02 March 2021

Notice about request to change development approval
(Given under section 83 of the Planning Act 2016)

Application Number: COM002-14/15
Description: Preliminary Approval for Material Change of Use (s.242 seeking to vary the effect of a local planning instrument) for the 'Biloela Shopping World Development Code', Material Change of Use for Retail/Commercial Complex (incorporating Commercial Premises, Shop, Showroom and Food Premises) and Food Premises (McDonald's Family Restaurant), Reconfiguring a Lot (5 into 2 lots and new road), and Operational Works (Advertising Sign)
Level of Assessment: Code & Impact Assessable
Site Address: 2 Gladstone Road, Biloela
34 Kariboe Street, Biloela
Lot & Plan Details: Lot 30 on SP293577, Lot 1 on SP301589, Lot 53 on SP126772 (Formerly 211SP119237, 30SP122571, 2SP121353, 30CP894250, 53SP126772)

PLAN AMENDED BY DEPARTMENT OF INFRASTRUCTURE, LOCAL GOVERNMENT AND PLANNING
DATE: 17 September 2015

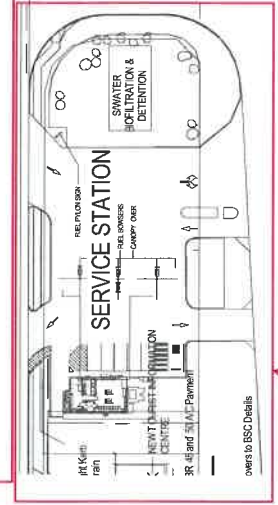
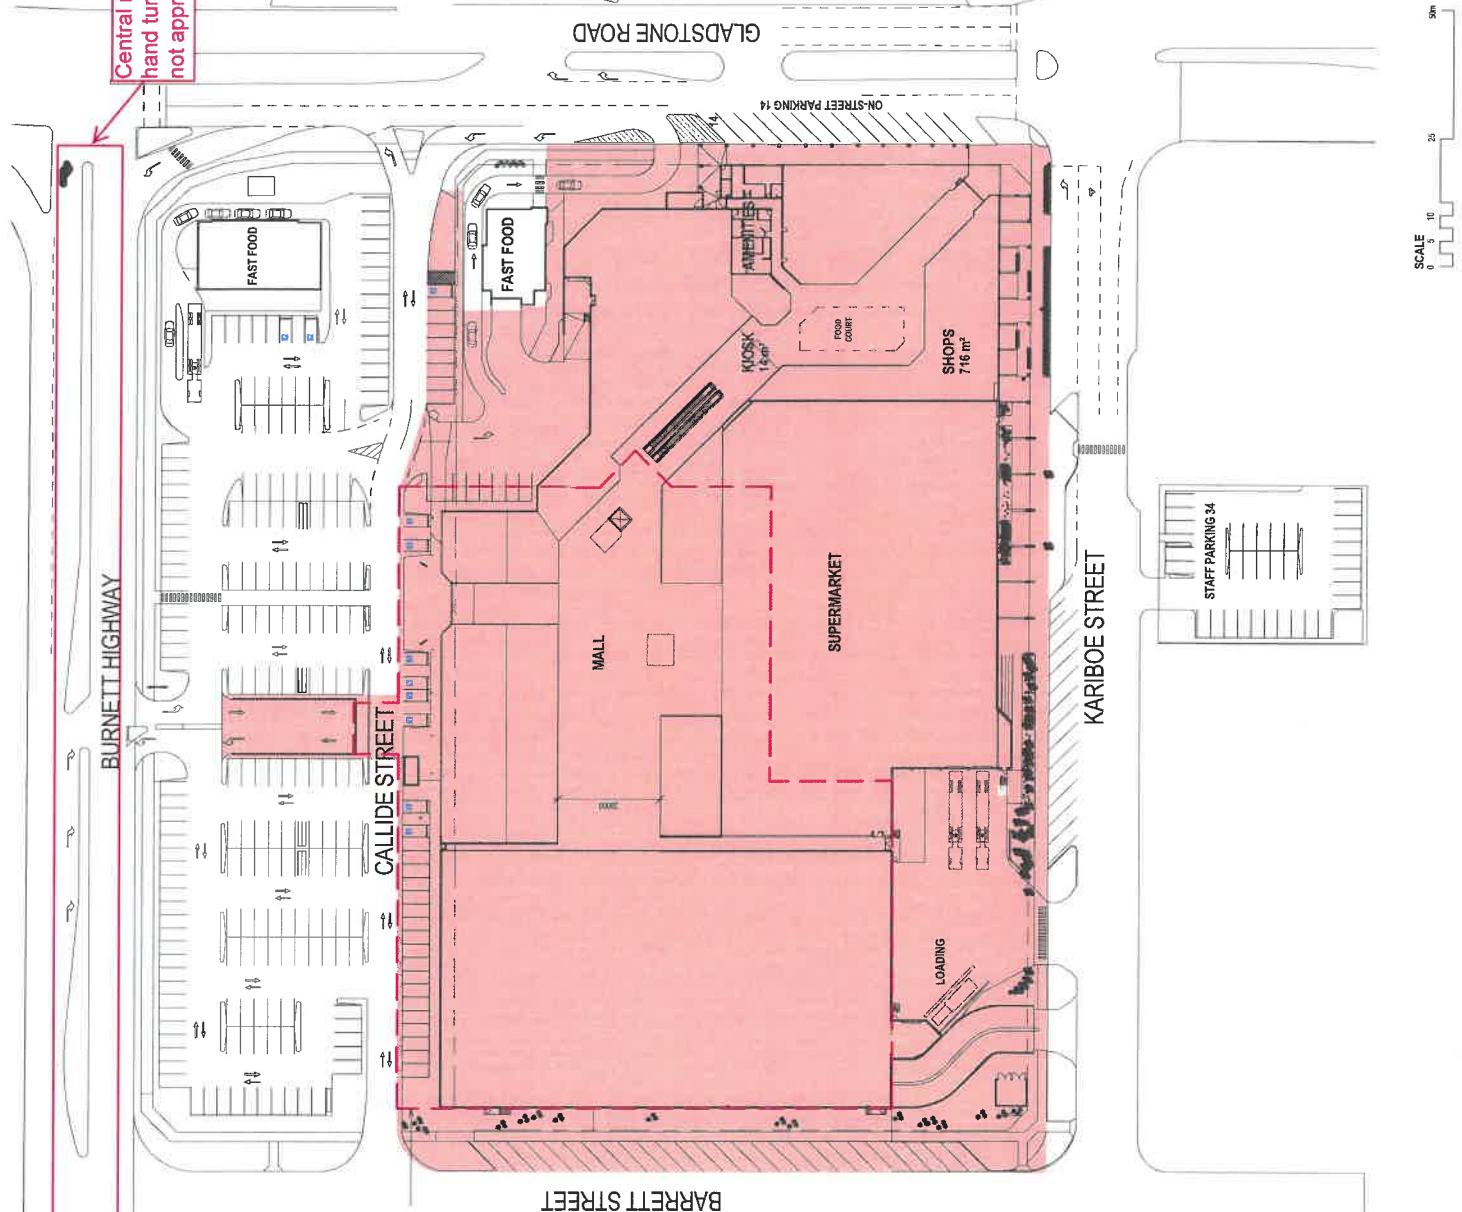
Central median works and right hand turn into permitted access not approved.

Service station subject of separate development application
